AGENDA
REGULAR MEETING OF THE
WINDSOR HEIGHTS
PLANNING AND ZONING COMMISSION
Wednesday, June 24, 2026 - 5:30 PM
WINDSOR HEIGHTS COUNCIL CHAMBERS - 1133 66th ST
ZOOM: <https://us02web.zoom.us/j/7832856334>
Meeting ID: 783 285 6334

Date: June 24th, 2026
To: Windsor Heights Planning and Zoning Commission
From: Trey Rouse
Subject: Site Plan: 900 64th Street – Walnut Creek Community Church

SITE PLAN FOR: WALNUT CREEK CHURCH ADDITION

We have received and reviewed comments from Bolton & Menk, dated June 10th, 2026, regarding the previously submitted Site Plan. Revisions and responses, written in bold type, are as follows:

2 PARKING SCREENING ENLARGEMENT
 1" = 10'

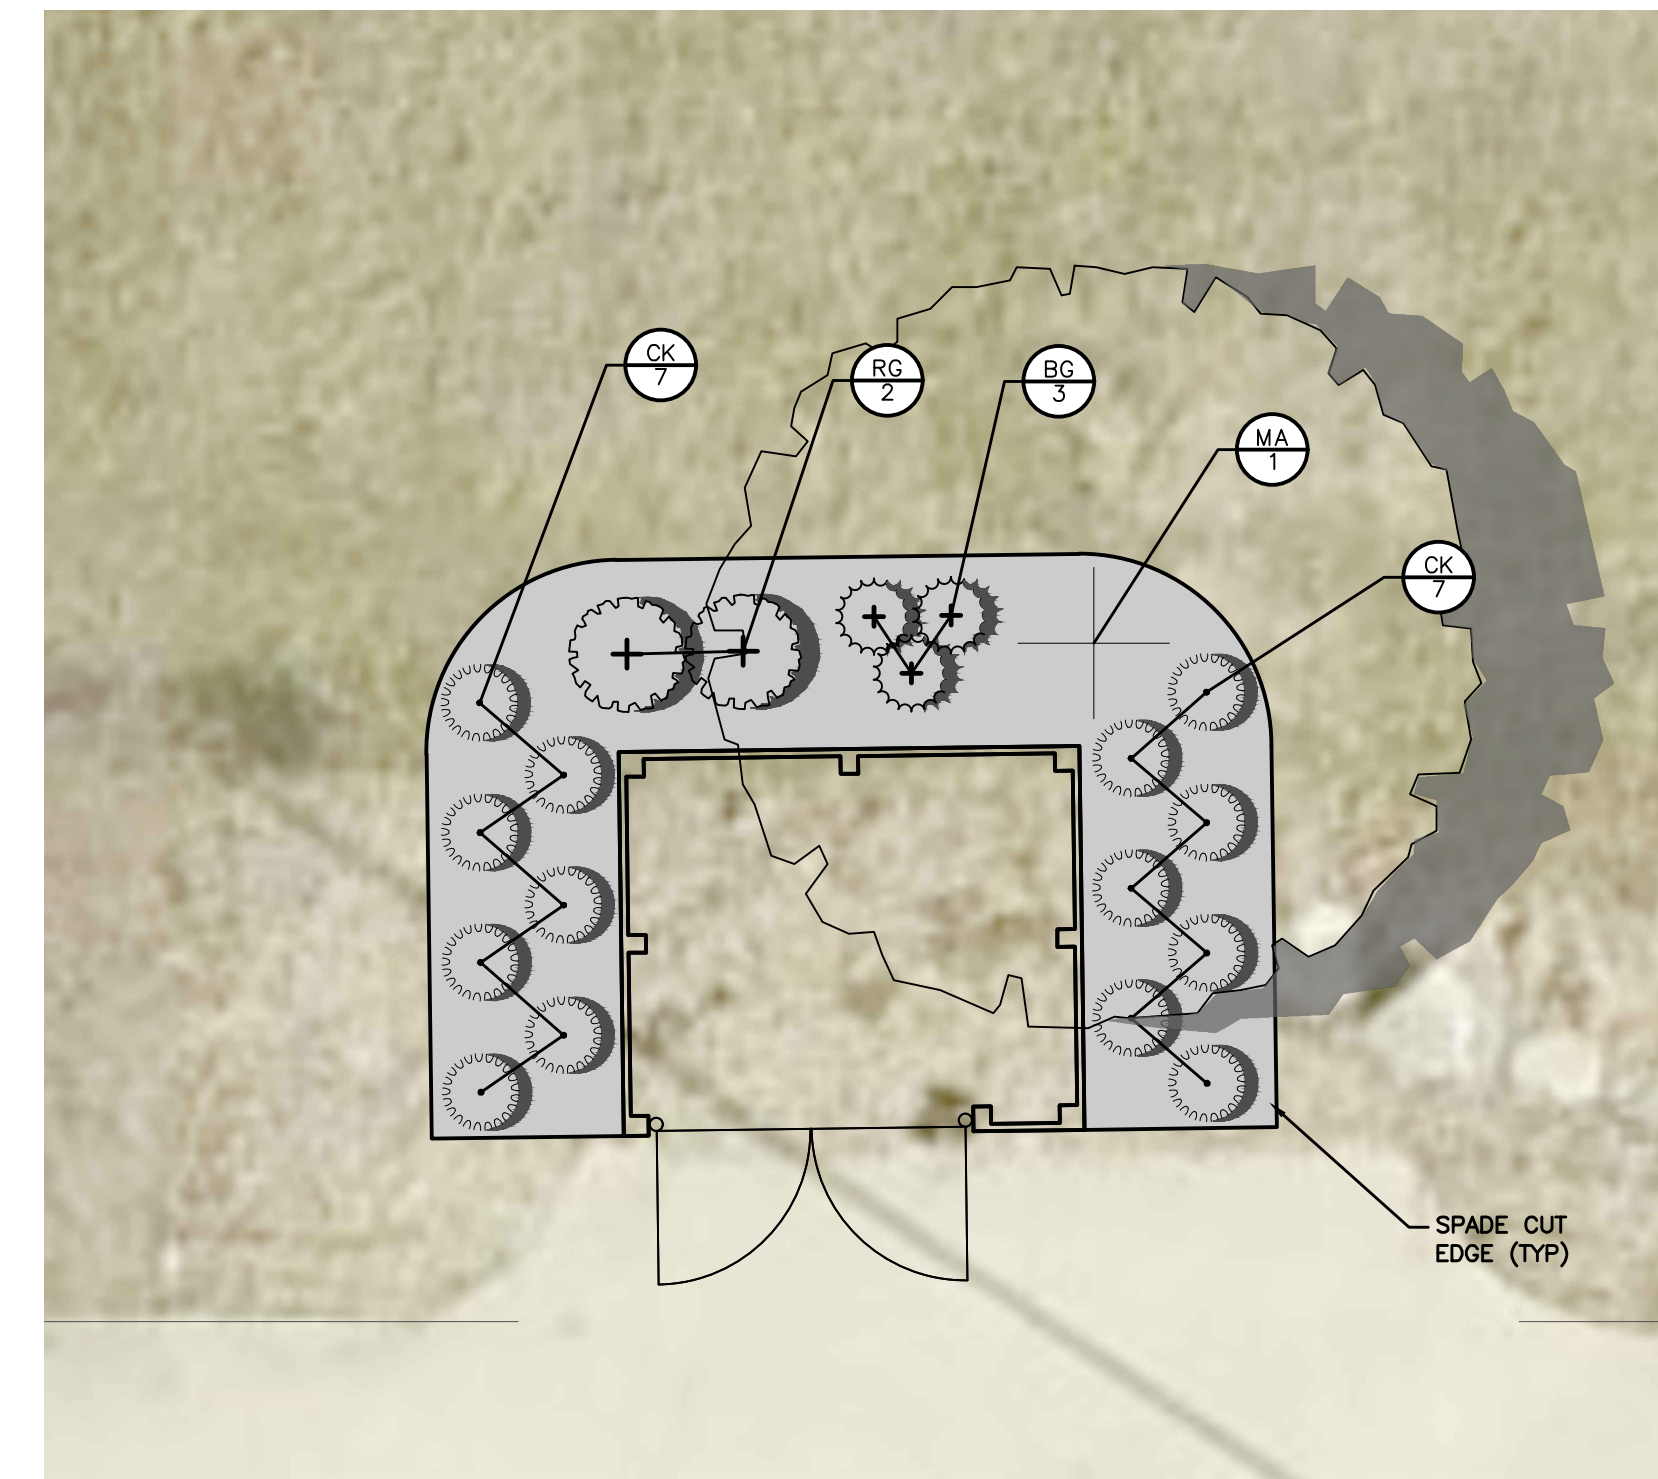
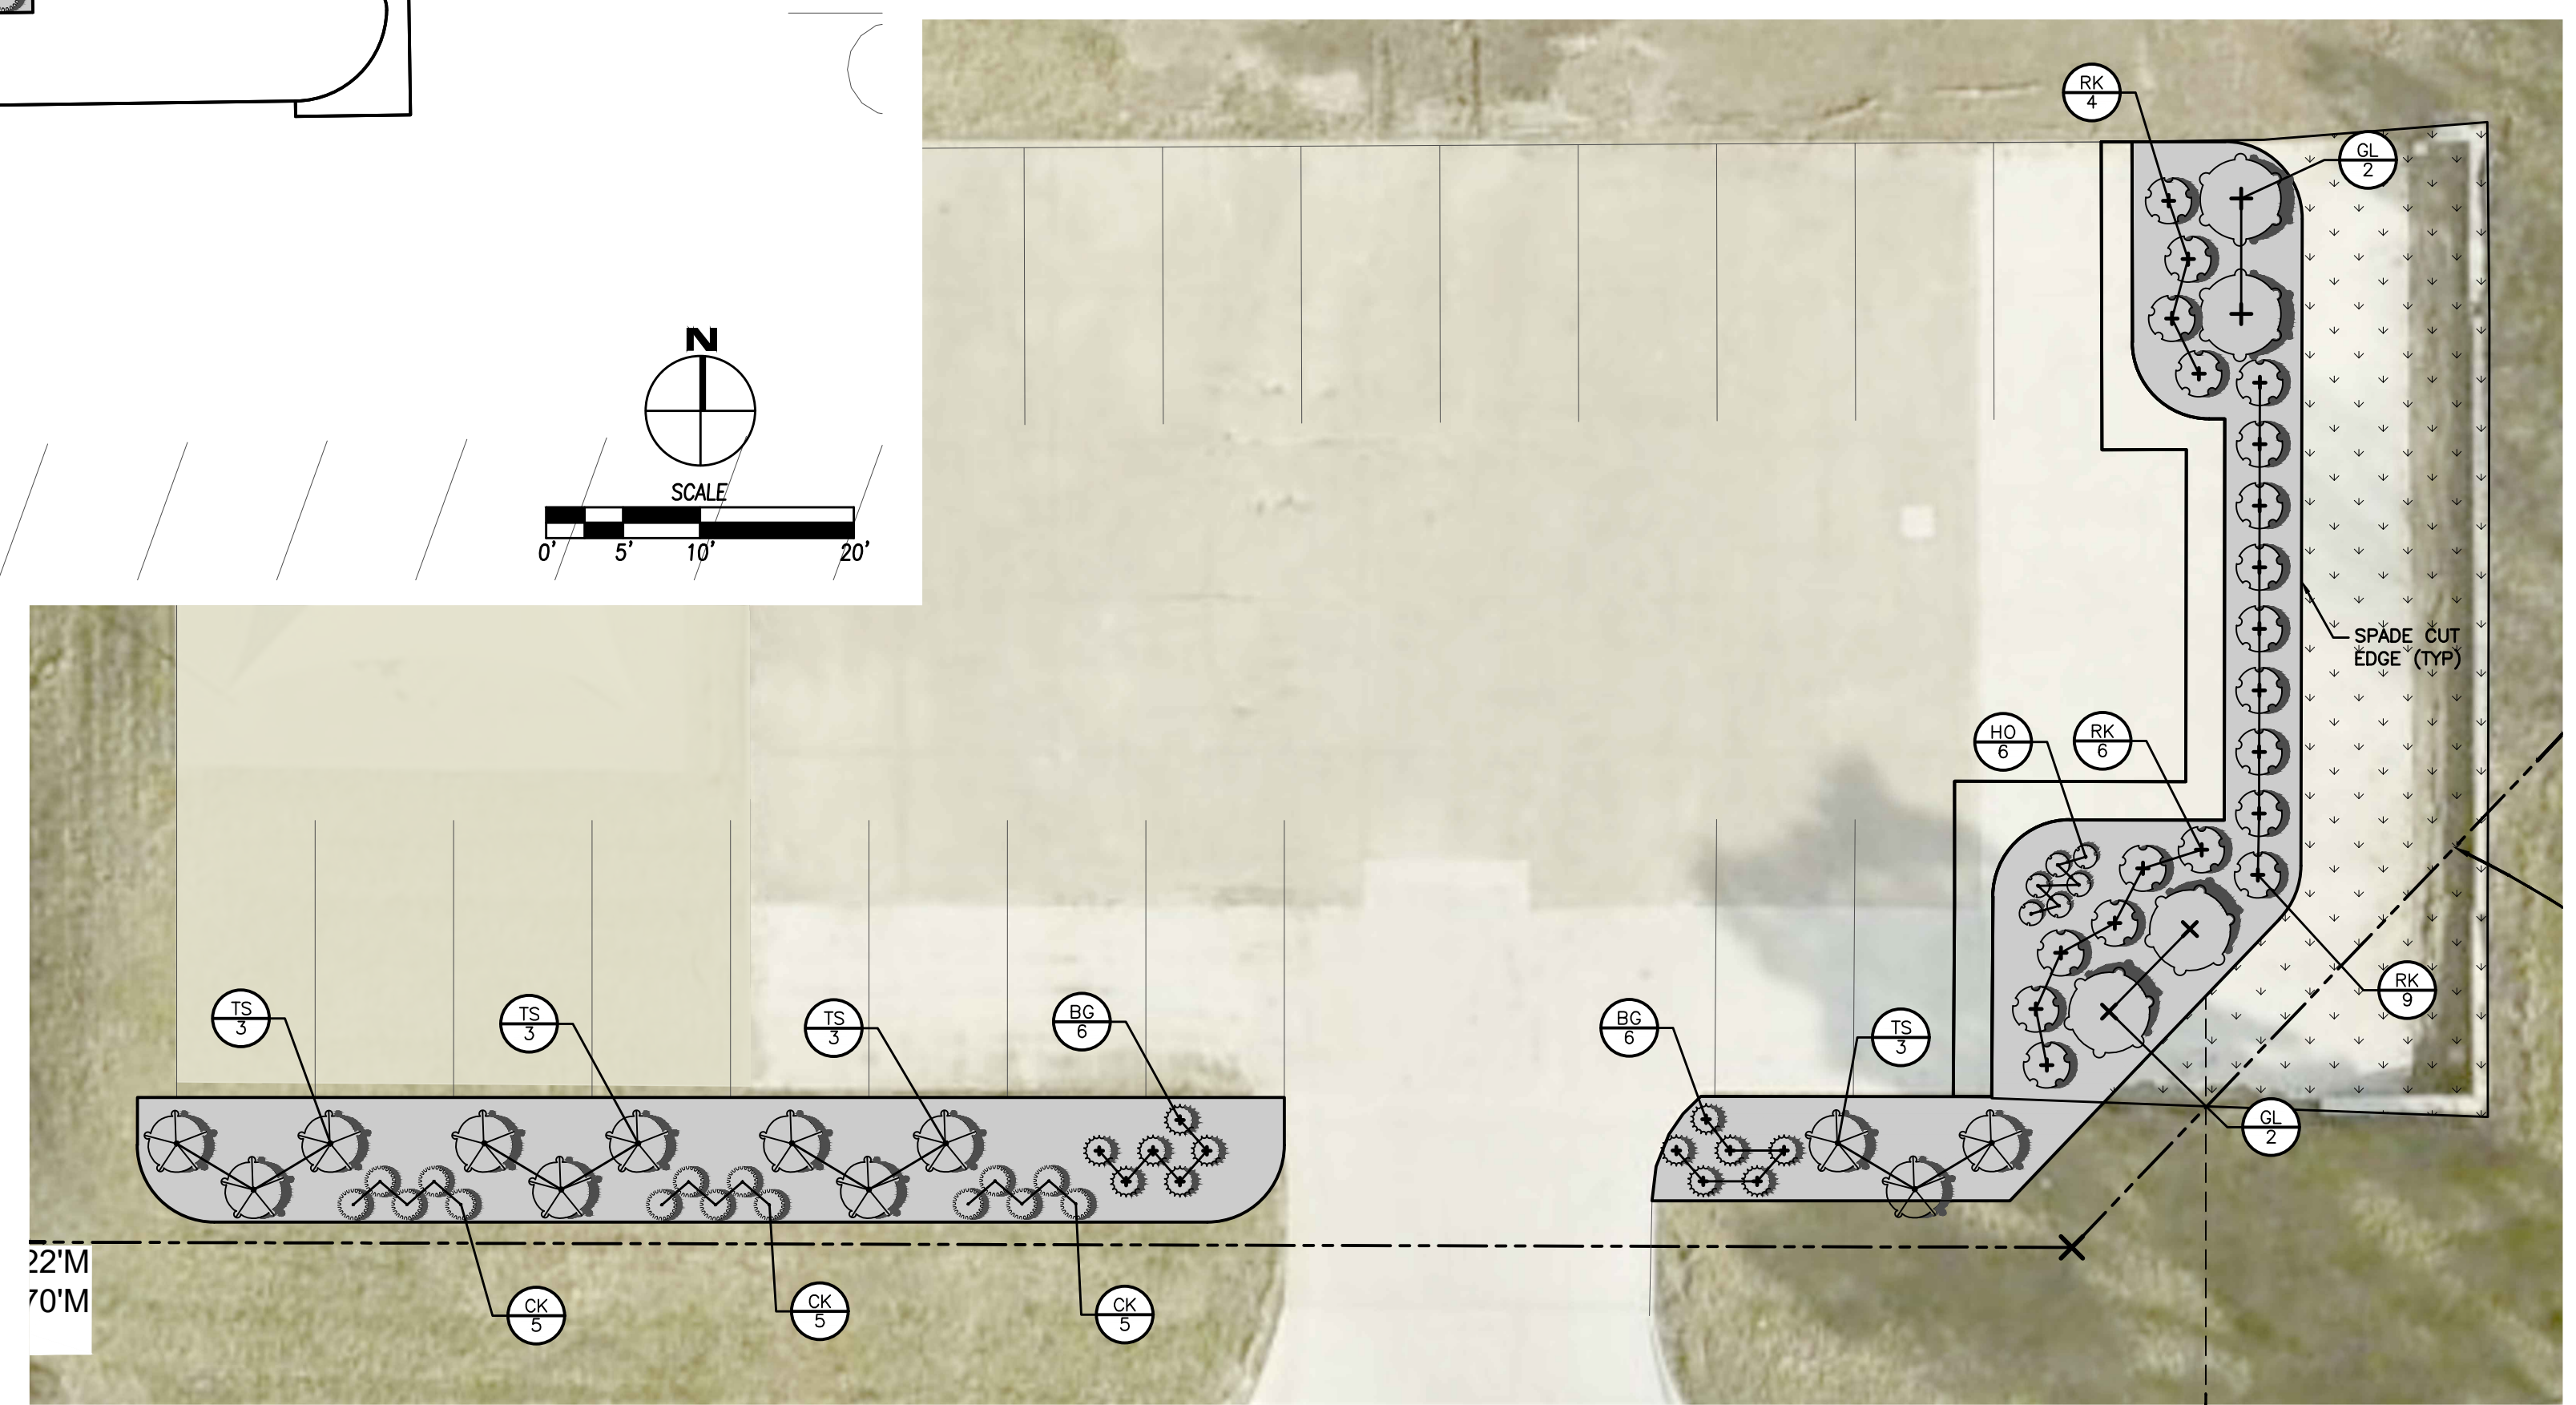
1. Sheet 9: Ensure all plants are labeled correctly and that details align with plans and code requirements.

2. Sheet 9: Provide screening along the south side of the SE parking lot that conforms to requirements called out in Chapter 174.08 Item 4.

3. Sheet 9: Refer to Chapter 173.04; Table 173.04-02 for minimum size requirements of plantings at time of installation.
 - a. Double Knock Out Red Rose is a shrub and must meet the requirements of such; please revise plant schedule to convey this information.

Landscape Plan has been revised accordingly.

Additional parking lot screening has been added to the Landscape Plan.

Plant schedule has been revised accordingly on Sheet L1.1 Landscape Plan.
